Bulletin

SUBJECT: Intelligent Light Out Detector (iLOD), A80271
CONCERN: Incorrectly installed component causing false current readings

NO: 2-06B
DATE: 8-18-2006
Revised
8-29-2006

Figure 1. Printed Circuit Board Serial Number Location

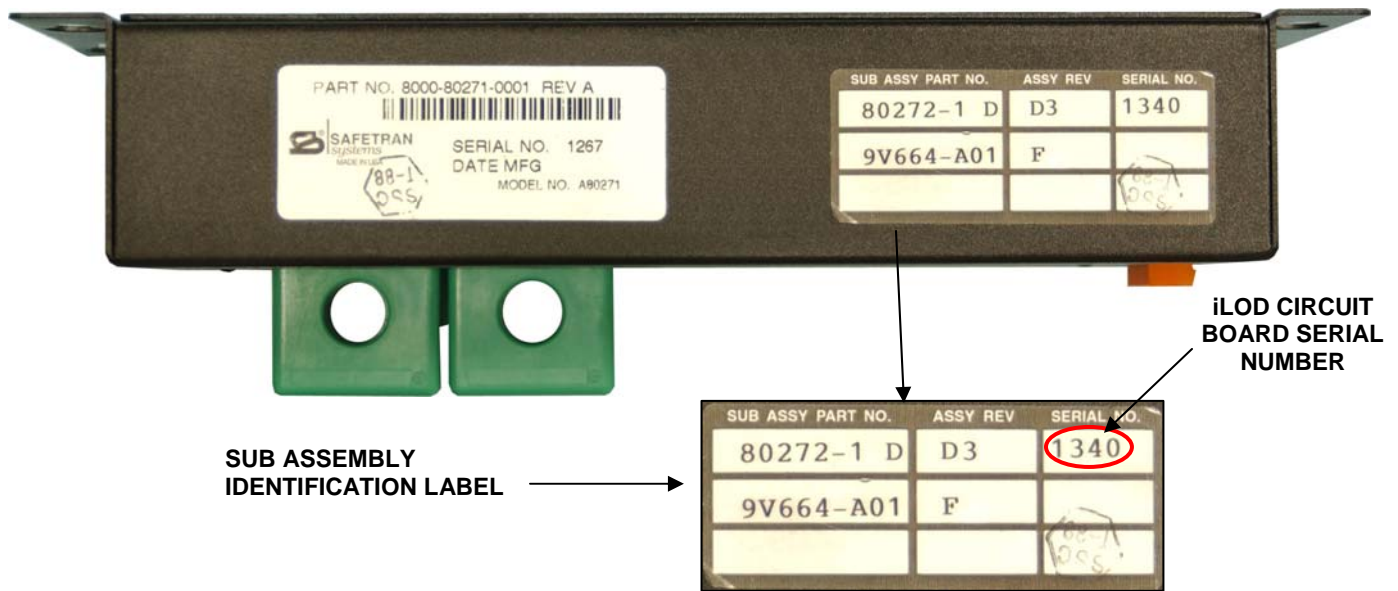
The original issue of this bulletin (PIB 2-06 dated 8-18-2006) incorrectly identified the iLOD assembly serial number when the reference should have been to the printed circuit board serial number. This has been corrected in the following information and in figure 1.

The serial numbers for the affected iLOD printed circuit boards range from 3700 through 4700. The serial number is located on a sub assembly identification label attached to the top of each iLOD assembly (see figure 1).

Figure 2. Update Label Location

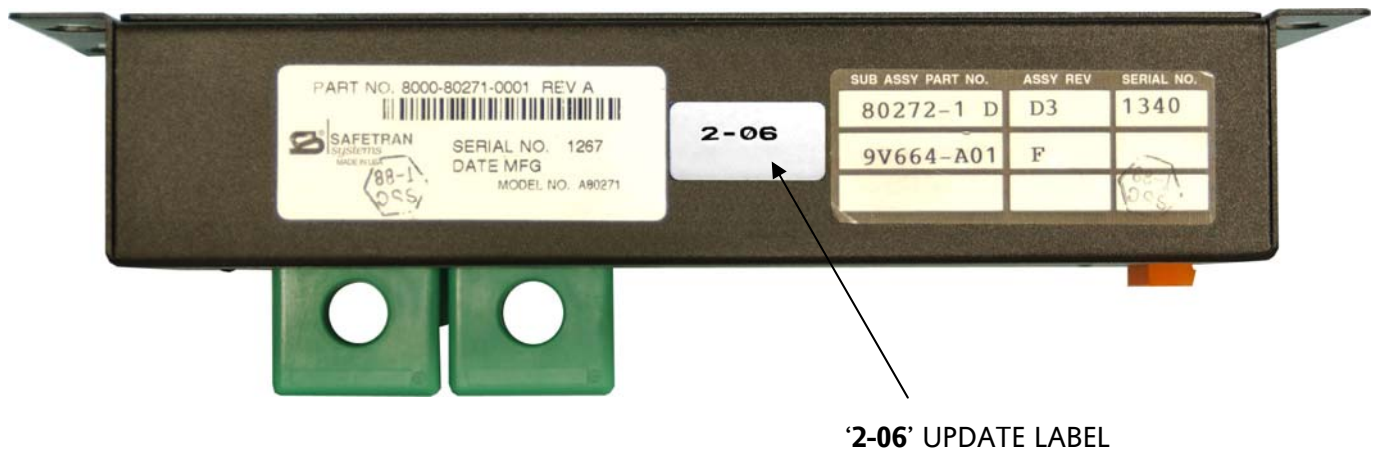
Returned iLOD assemblies will have the capacitors replaced with correct polarity and will then be tested and added to the seed stock. Units with corrected capacitor polarity can be identified by a label marked '2-06' and attached adjacent to the sub assembly identification label (see figure 2).
